**Planning Commission Application  
PART I**

Address of Subject Property 3732 MONTROSE ROAD

November 2, 2016

Additions and Renovations to St. Luke's Church (Planning Commission P-16-24)  
#166009-00

## PROPOSED SITE DEVELOPMENT PLAN

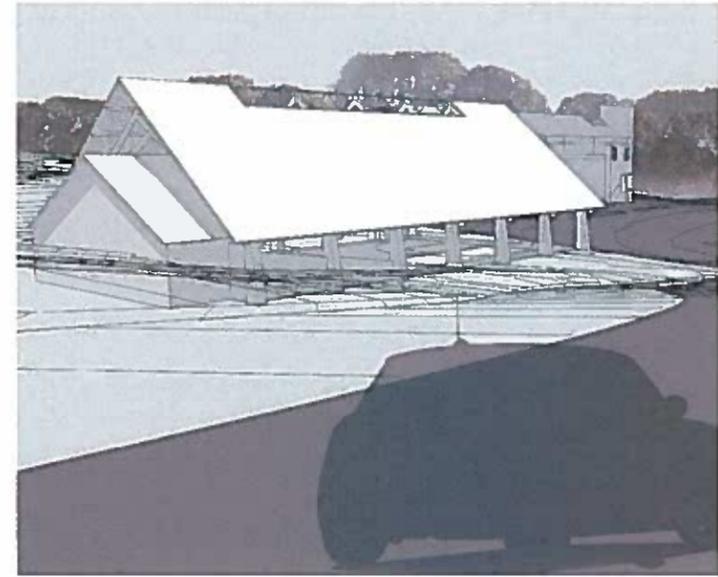
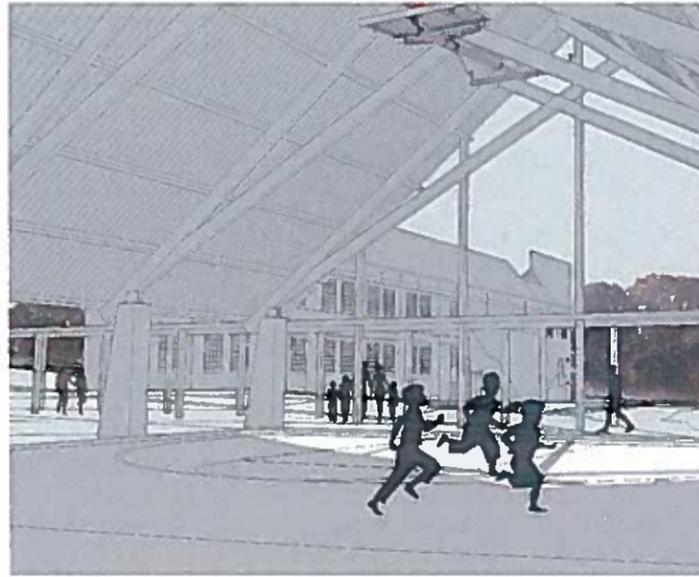
This letter with attachments constitutes incorporates all previous changes to the original submission and the responses to all questions posed by the Planning Commission in its meetings of September 6 and October 3.

- Attachment A consists of the original development plan documents submitted for this case that have been revised to reflect all subsequent changes made in response to PC requests. These include changes in the size and position of the proposed new parking lot to incorporate the change in gate location, the new sewer easement, changes to the landscape buffer and a reduction in the overall number of spaces from 27 to 21. It also provides for a foot path to the house and repositions the pavilion slightly further away from South Cove. The number of new parking spaces has been changed as a result of the reduced size of the new parking lot. The height of the pavilion has been changed to 35 feet.

1 PLAN  
SITE PLAN - ELECTRICAL  
E1.10

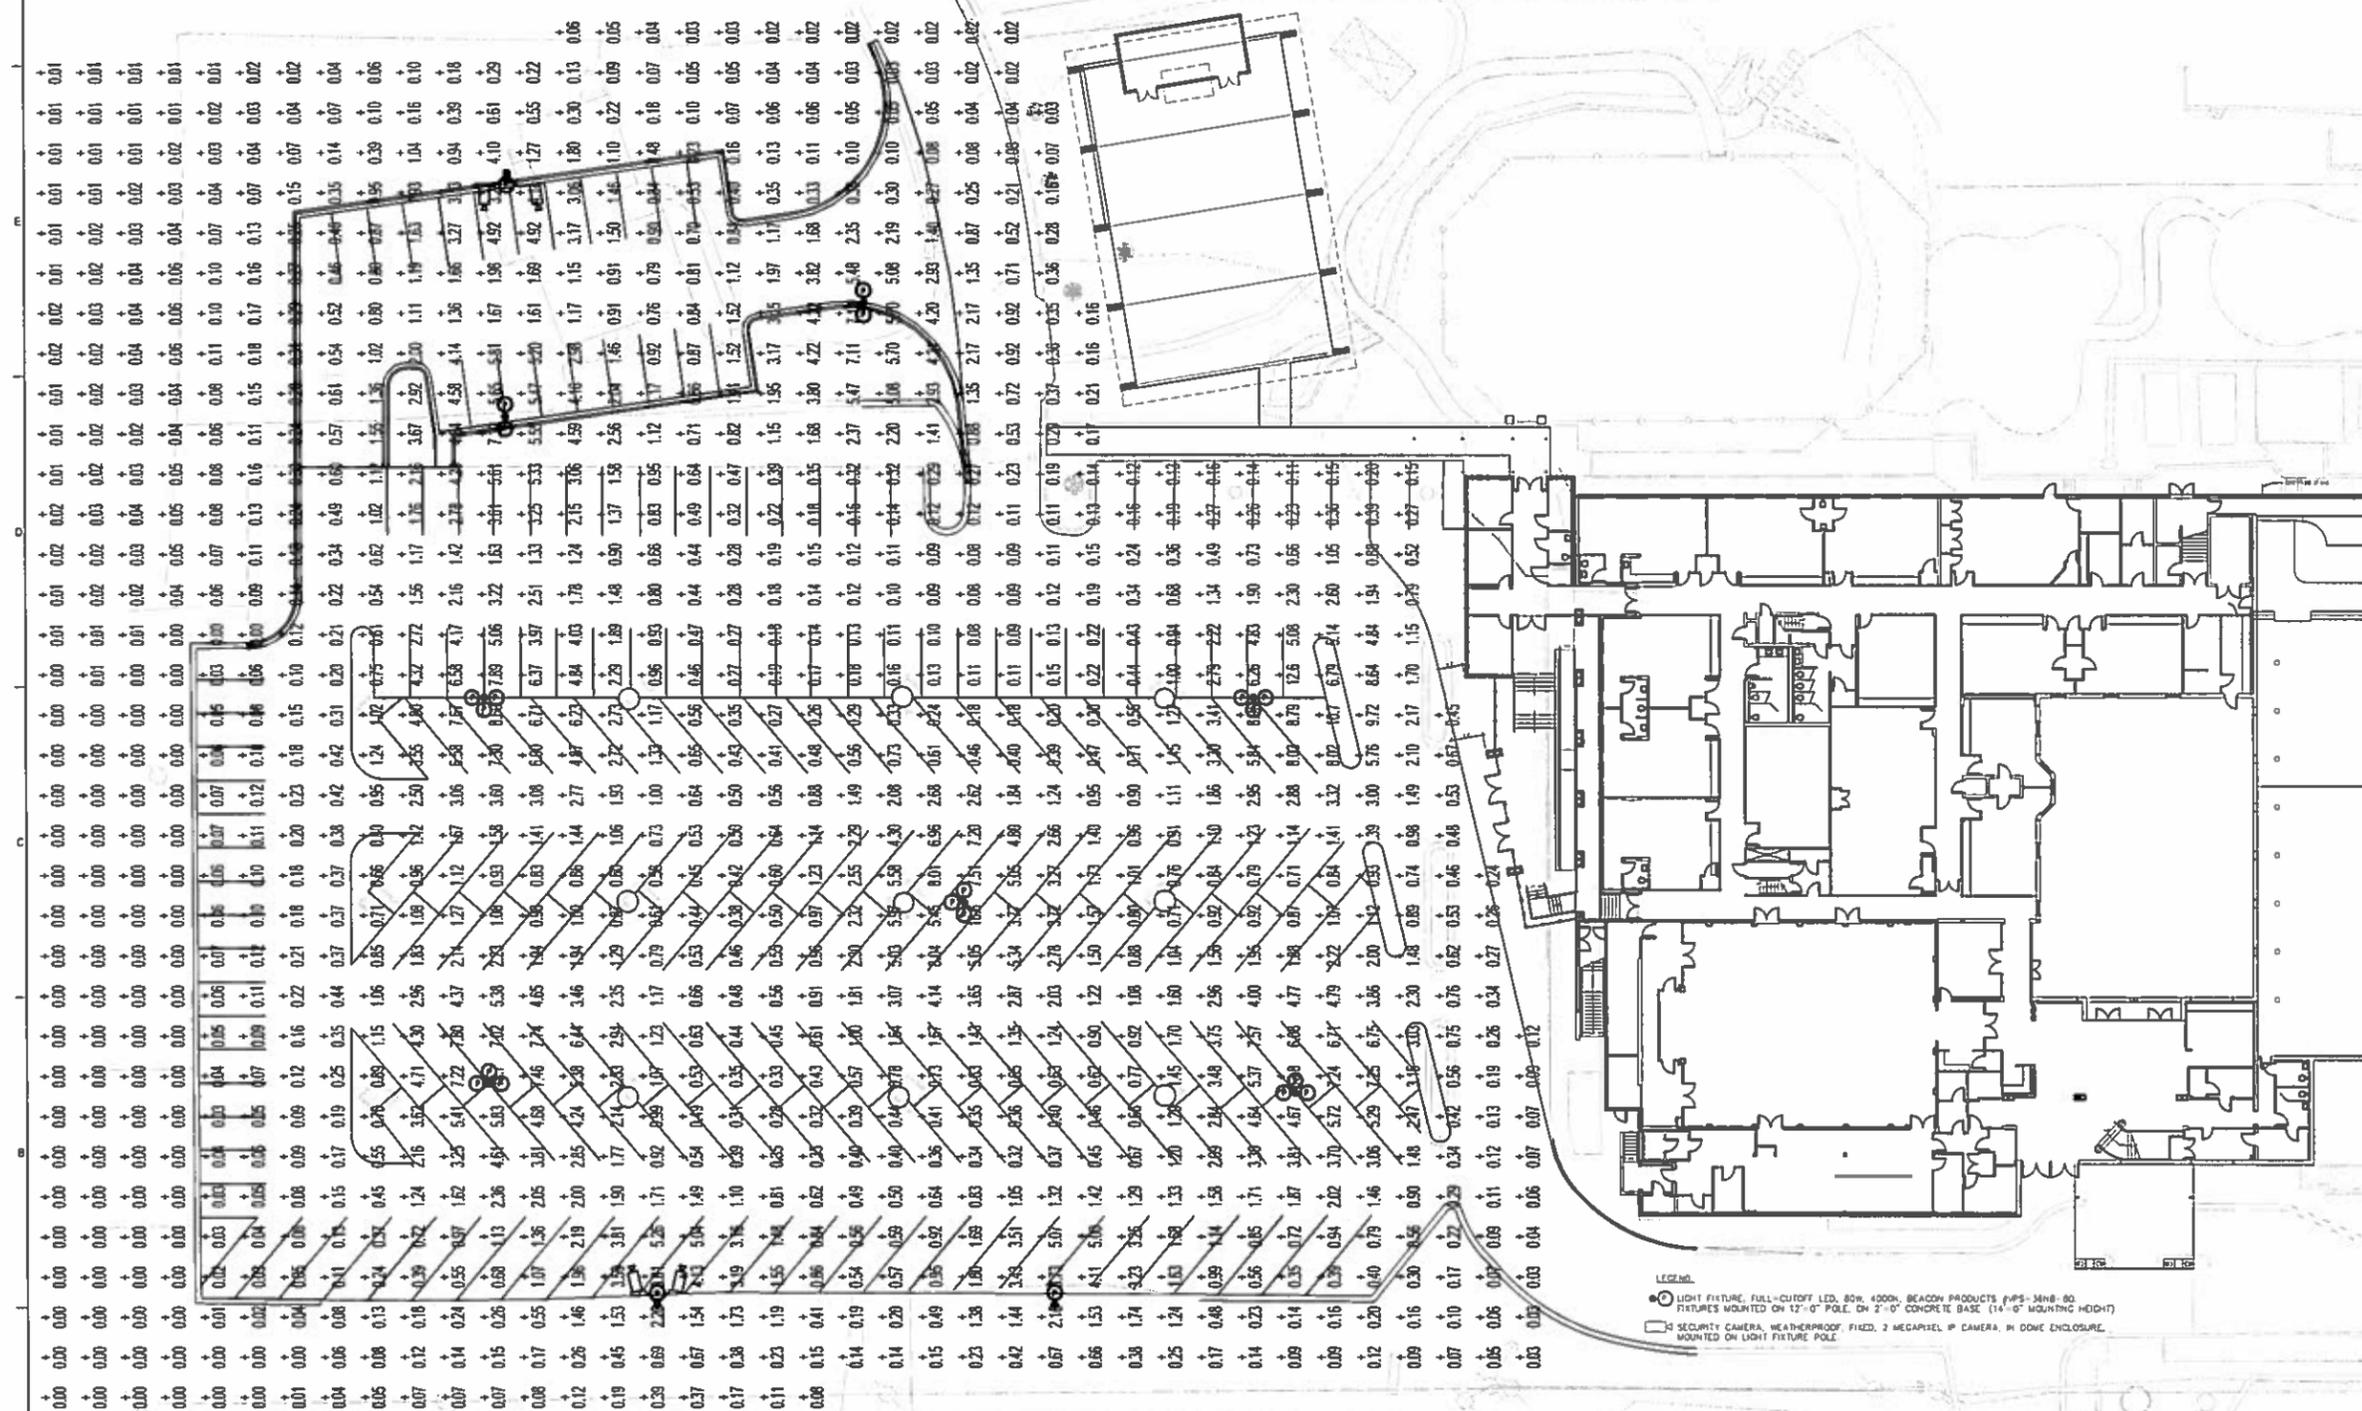
- *Photometric study of the lighting proposed in the proposed parking lot; and for that of existing parking lot if re-lamping is proposed. Type of light fixtures and a schematic placement in the new lot.*

Response – See Attachment B consisting of a schematic plan and photometric study of the two parking lots. The new parking lot has been adjusted in size to agree with the changes requested by the PC and Jefferson County's requirements. The photometric study is based on replacing all existing poles and installing new ones which will meet the 14 foot maximum height limit. New poles include several in the existing lot to cover spots that do not currently get any light as well as two poles in the new lot and another at the end of South Cove to cover the two gates. The new pole lights will not be any closer to the north property line than the current ones. Also included as a part of Attachment B is a specification sheet on the new poles and the LED lamps. These are low cut-off type fixtures. The lighting design is in accordance with IES recommended lighting levels to minimize glare and light trespass beyond property lines.

DRAWING TITLE  
**PARKING LOT  
 PLANTING PLAN**

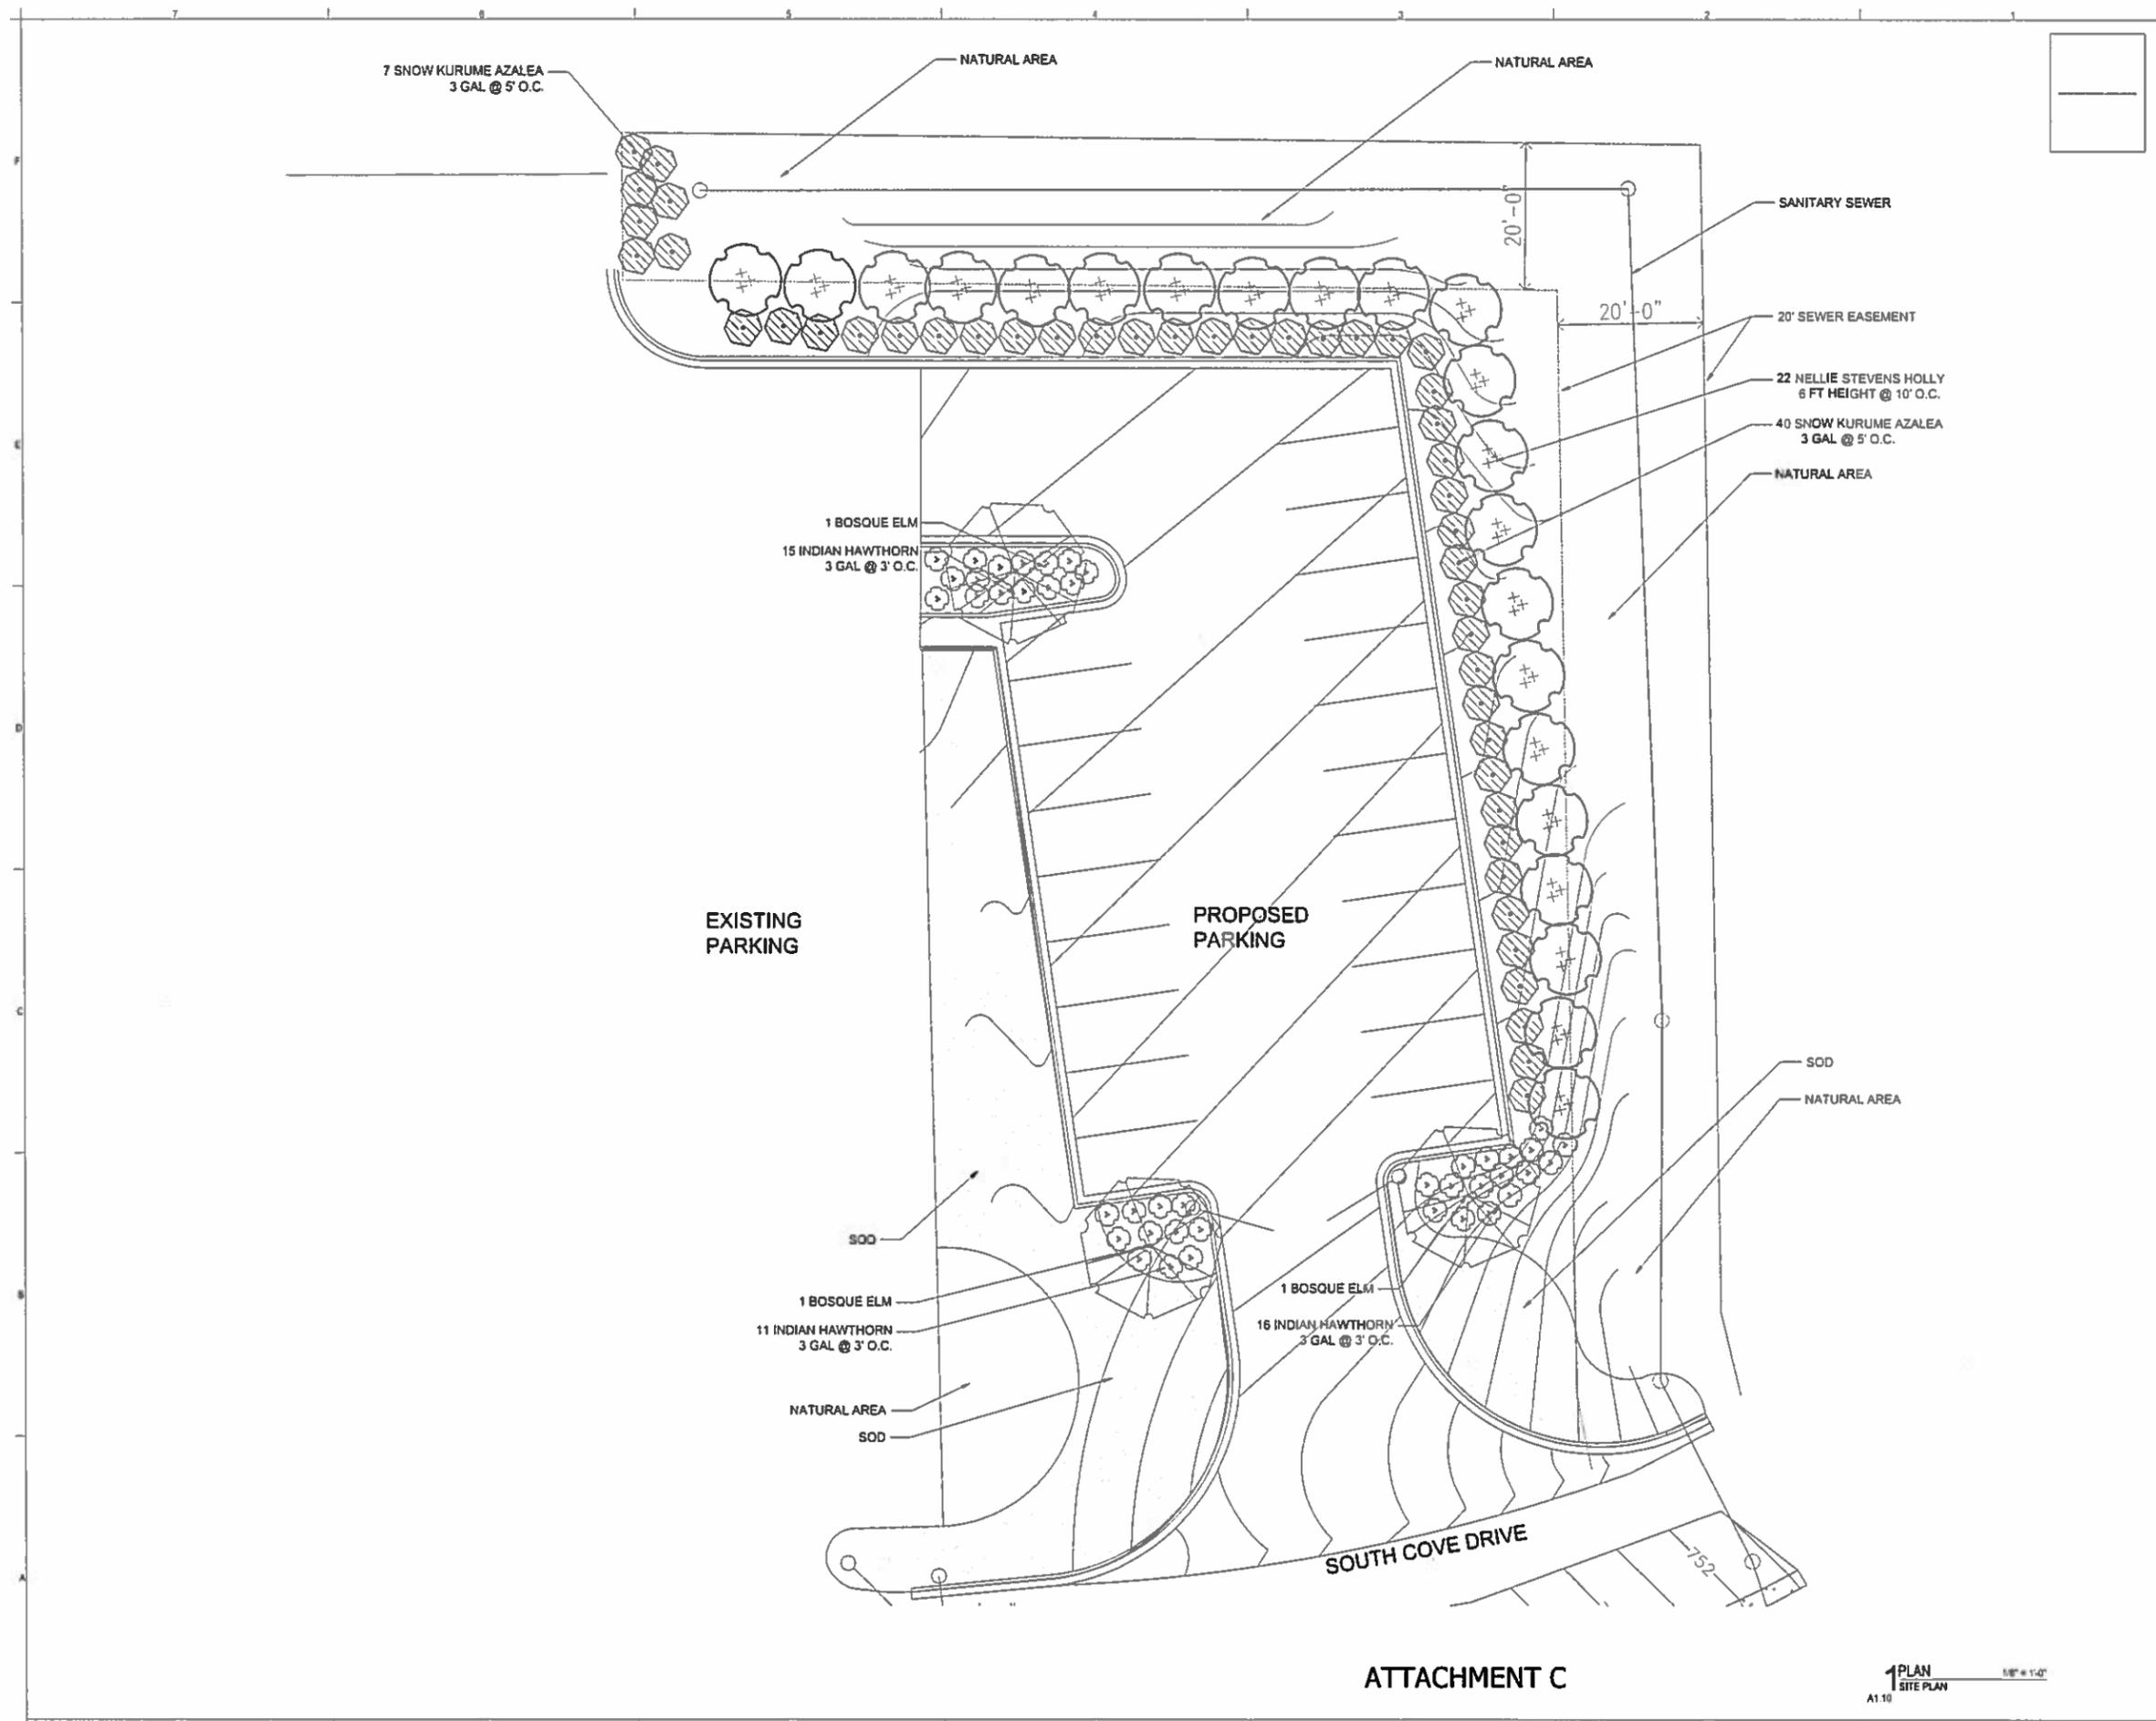
- *Schematic of the proposed landscape buffer – type of plants and location, especially in the sensitive areas along the east and north sides of the parking lot, as well as between the proposed pavilion and the south edge of the vacated South Cove Drive.*

- *Information on security cameras: placement and capabilities.*

Response – See Attachment C consisting of two landscape drawings showing proposed schematic buffer landscaping of the new parking lot and another showing the proposed schematic landscape of the area around the proposed outdoor pavilion. Both of these drawings have been revised to reflect a) the reconfiguration of the new parking lot and b) the repositioning of the pavilion. The proposed plant material at the parking lot is now consistent with our original proposal for Nellie Stevens Hollies.

Response – See Attachment C for placement and for camera specifications. The cameras will be stationary but designed to cover the entire parking lot area from these locations including that area of South Cove that is immediately outside the two gates. The lighting has been designed for reasonable uniformity across all parking areas and to allow for maximum performance of security cameras.
